FOC ESC — PCB Layout & Stackup Guide

STM32G473 · DRV8328 · inline shunts + INA240 · AS5047P · Ø60 mm 4-layer board · 24 V / 10 A pk / 5–8 A cont · JLCPCB fab

1. Final architecture & review verdict

Fig. 2 — Placement map, Ø60 mm. Power arc north, quiet zone south, encoder alone on bottom center. Mounting holes shown for motor standoffs — fix these and the connector positions *first*, they are mechanical constraints.

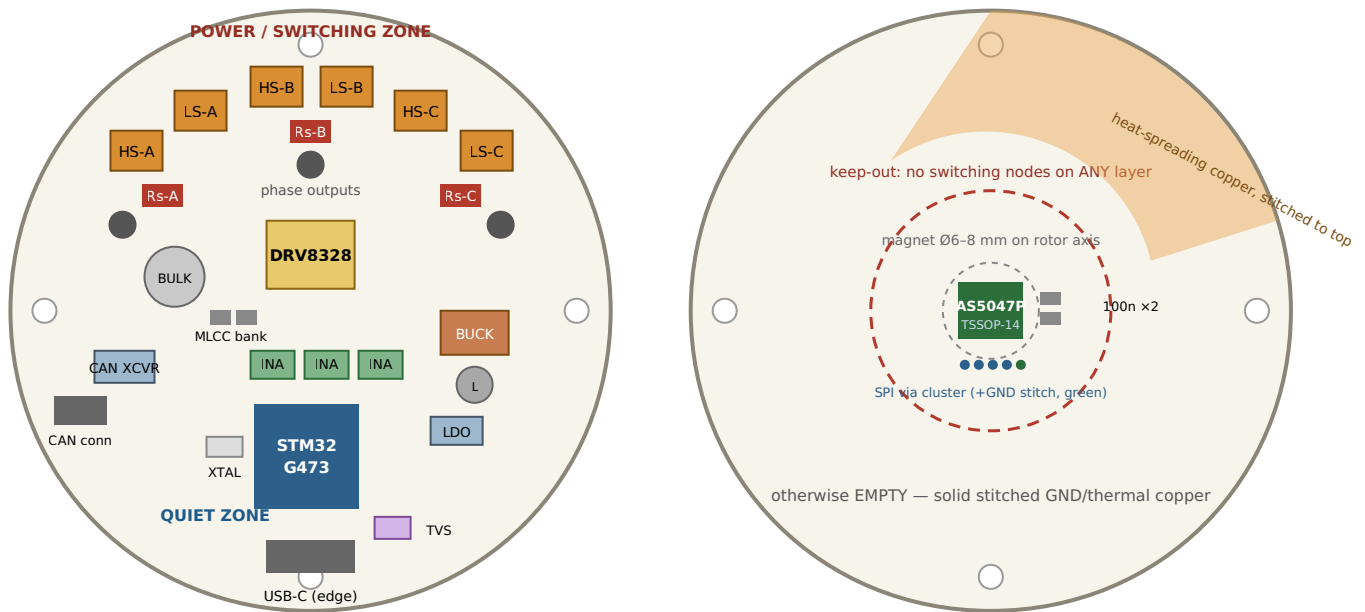
Placement verdict — ACCEPTED with refinements. "Everything on top, encoder alone on bottom" is the proven layout for this class of board (moteus r4 is Ø46 mm and does exactly this). It buys you: single-side assembly (cheaper JLC SMT run, one reflow pass), an almost-empty bottom that becomes a clean magnetic/electrical quiet zone, and free heat-spreading copper on the bottom. Cost: the top layer is crowded — placement discipline decides whether this board works.

- **Partition, don't moat.** One contiguous ground everywhere; separation is *spatial* — switching components clustered in one region, sensitive components in another, so their return currents occupy different areas of the same plane. TI's motor-driver layout app note (SLVA959) is explicit that this is partitioning of *placement*, not split grounds.

- **Order of placement:** ① mounting holes + connectors + encoder axis (mechanical, immovable) → ② FET bridge + shunts + phase pads as one tight arc → ③ DRV8328 centered on the bridge → ④ decoupling at the bridge → ⑤ INA240s against the shunts → ⑥ MCU so that ADC inputs face the INA240 outputs and SPI pins face the center → ⑦ everything else.

- **The buck is a second noise source.** Treat it like a fourth half-bridge: its input hot loop and SW node get the same care, and it must not sit between the shunts and the INA240s, nor within the encoder keep-out cylinder.

Fig. 1 — Stackup. Physical orientation: “top” faces away from the motor, “bottom” (encoder) faces the magnet.

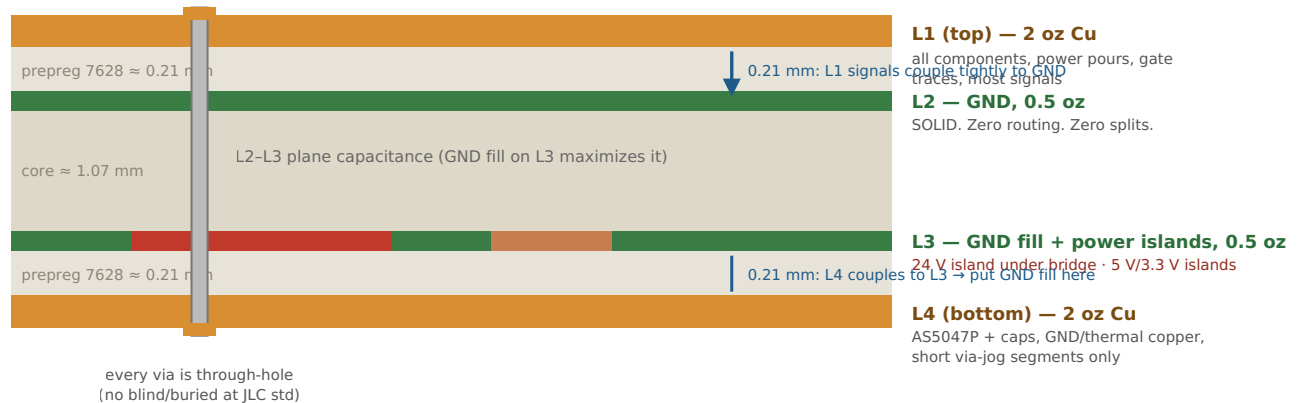
Stackup verdict — ACCEPTED with one change. The proposed stack (top: everything / GND / power / bottom: encoder) is correct in structure. Change: L3 should not be a wall-to-wall power plane. Make L3 **GND fill with power islands** (24 V island under the bridge, 5 V/3.3 V islands where needed). Reason in §3.

Copper verdict — 2 oz outer / 0.5 oz inner. Your trace calculation is correct but answers the wrong question. Detail in §3.3.

Why: every signal trace is one half of a transmission line; the return current flows in the copper *directly underneath it*, concentrated within roughly $\pm 3\times$ the dielectric height. With 0.21 mm to the plane, the loop area of every top-layer trace is tiny → low inductance, low emission, low pickup. This is why sig-GND--GND-sig style stacks are recommended: **both** routing layers get a close reference. Your stack achieves the same thing as long as L3 under the bottom routing regions is ground fill — which is exactly why L3 must not be a solid 24 V plane.

- Anything routed on L4 (SPI jog, USB jog, encoder caps) would otherwise reference the 24 V plane. Return current would have to displace through the L2-L3 plane capacitance to get back to GND — a larger, lossier, noisier loop.
- A 24 V island only needs to exist under the bridge/bulk-cap region. 0.5 oz plane copper has $\approx 1 \text{ m}\Omega/\text{square}$; even a modest island carries the DC feed with millivolt drops. The *switching* (AC) current never needs L3 at all — it circulates in the top-layer hot loop (§5).
- GND fill on L3 doubles as the second reference plane and adds interplane capacitance across the thick core.

Your number ($\approx 11 \text{ mm}$ of 1 oz for 10 A at 5 °C rise) is a correct IPC-2221-style *ampacity* result, and it proves ampacity is not the constraint — on a Ø60 mm board you will use pours, and pours are far wider than 11 mm. The actual reasons to pay for 2 oz:

Fig. 3 — What happens at a layer transition. The signal changes layers instantly; its return current can only follow if you give it a ground path at the same spot.

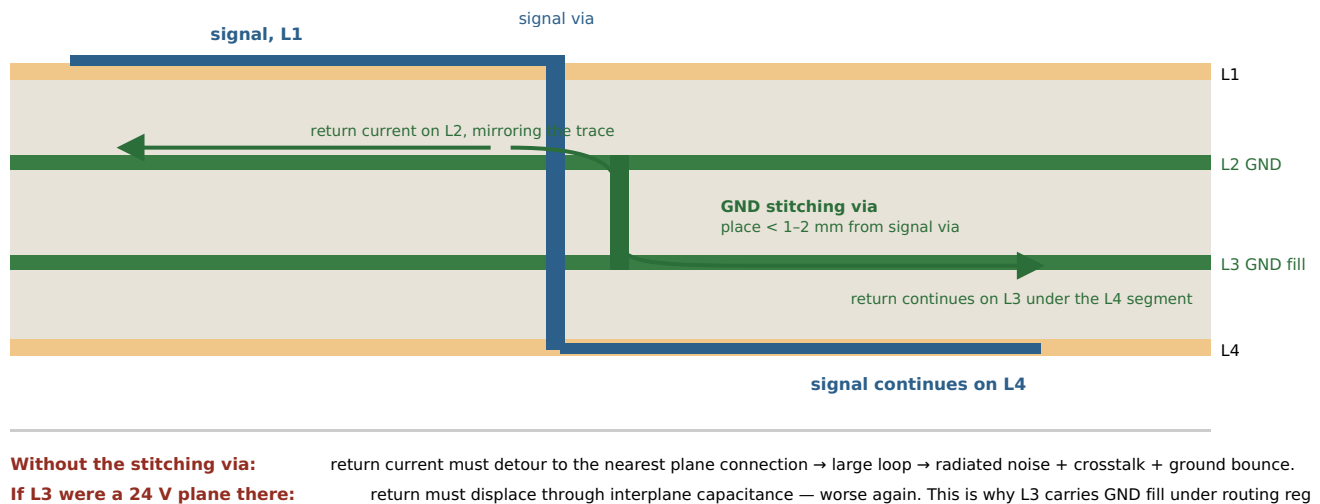
R3 — Every signal layer-change gets a GND via within 1-2 mm. For high-speed or clock-bearing nets (SPI SCK, USB), make this non-negotiable; for slow GPIO it's good hygiene.

Why: Fig. 3. The stitching via is the bridge that lets the return current change planes with the signal.

Fig. 4 — One half-bridge with its decoupling and the switching (“hot”) loop. Note the shunt is in the **phase output** (inline sensing), outside the hot loop — one of the benefits of in-line shunts over low-side.

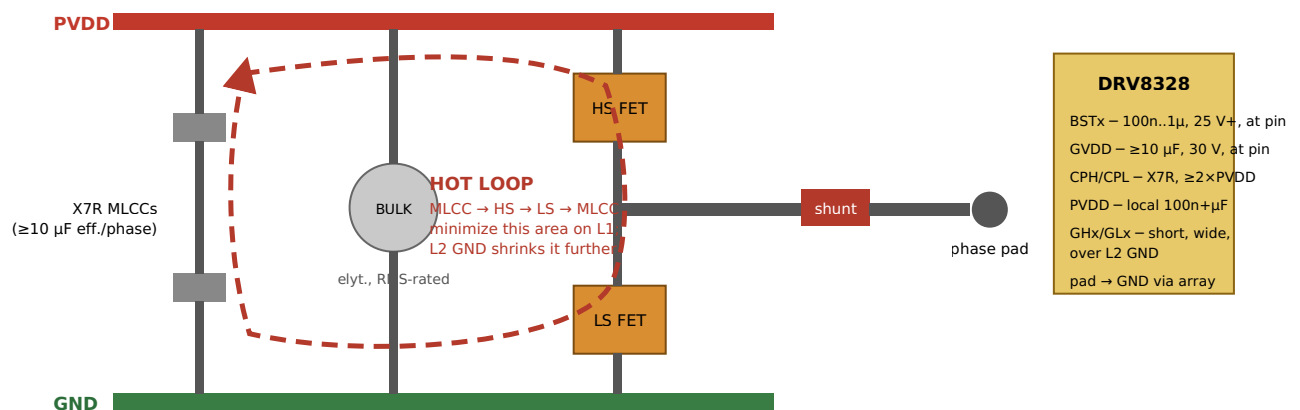
Repeat ×3. The dashed loop carries the full switched current with ~ns edges — its area sets your EMI and phase-node ringing. Place the MLCCs so this loop closes in millimetres on L1; the bulk cap sits just behind them and only handles low-frequency ripple.

- **Arrange each half-bridge as one vertical strip:** PVDD pour → HS drain pad; HS source → phase copper → LS drain; LS source → GND pour. Phase copper connects onward to shunt → phase pad. Minimal jumps, zero vias in the current path on L1.
- **Per-phase MLCC bank between PVDD and GND at each half-bridge** — target $\geq 10 \mu\text{F}$ effective at 24 V bias (means ~2–3× nominal after DC-bias derating; e.g. $3 \times 10 \mu\text{F}/50 \text{ V}$ X7R 1210 per phase). Place them to physically close the Fig. 4 loop.

Fig. 5 — Kelvin connection. The measurement sees only the shunt element, never your copper (Cu is ~ 3900 ppm/ $^{\circ}$ C — 80 $\times$ worse tempco than the shunt).

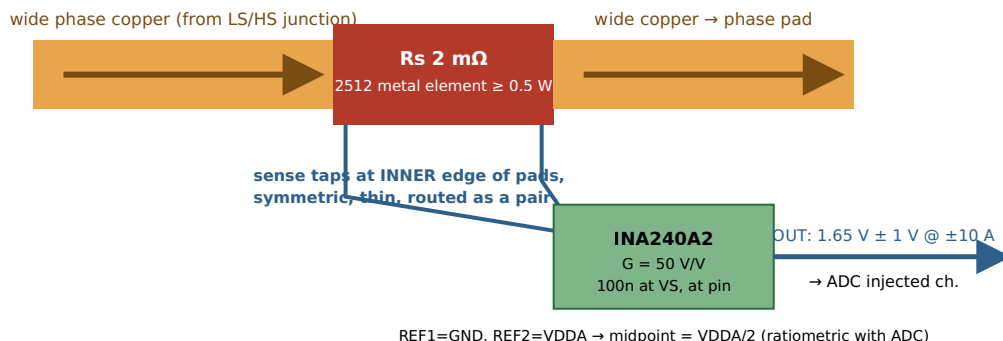
✗ no vias in the sense path ✗ no current-carrying copper between tap points ✗ don't tap the pour — tap the pad

Item	Requirement
Shunt connection	Kelvin / 4-wire, per datasheet §"Connection to the Current-Sense Resistor" — any shared current-carrying impedance appears as gain/offset error against a 2 mΩ element
Bypass	0.1 μ F at VS-GND, at the pin; VS = 3.3 V rail (VDDA) so output range matches ADC
REF pins	Output midpoint = $(V_{REF1} + V_{REF2})/2$. Use REF1=GND, REF2=VDDA → 1.65 V midpoint that tracks the ADC reference (ratiometric — offset drift of the rail cancels in the conversion). Firmware still calibrates the true zero code at startup with the bridge disabled.
Input filtering	None required — the part is designed for direct PWM-node connection (enhanced PWM rejection). If you add RC anyway, keep R small (< 10 Ω) and matched; mismatch converts common-mode transients to differential error.
Placement	As close to the shunt as the power arc allows; sense pair length matters less than symmetry and distance from dv/dt nodes

Fig. 6 — D± pair merging, the single L4 crossing jog, and flow-through TVS routing.

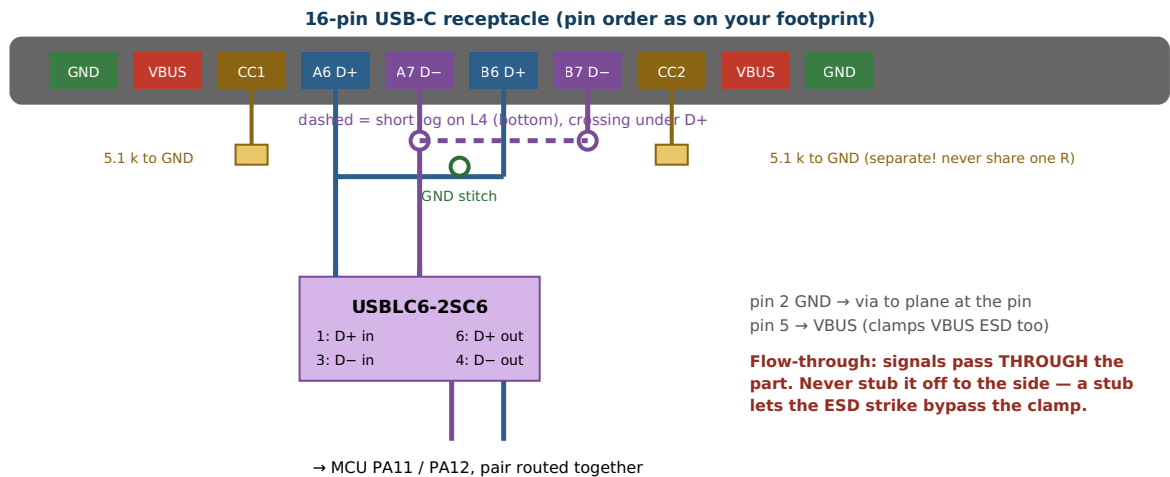
- **Yes, tie the pairs:** $A6+B6 = D+$, $A7+B7 = D-$. Mandatory, not optional — the host drives whichever pair the plug orientation lands on. Merge them *at the connector*, before the TVS, so both stubs stay short.

- **The crossing:** exactly one net needs a two-via jog. Route it on L4 (R2), a few mm long, over the L3 GND fill, one GND stitch via beside the pair. At full speed (12 Mbps, ~10 ns edges) the stub and impedance discontinuity are negligible — do not lose sleep over 90 Ω matching on this board.
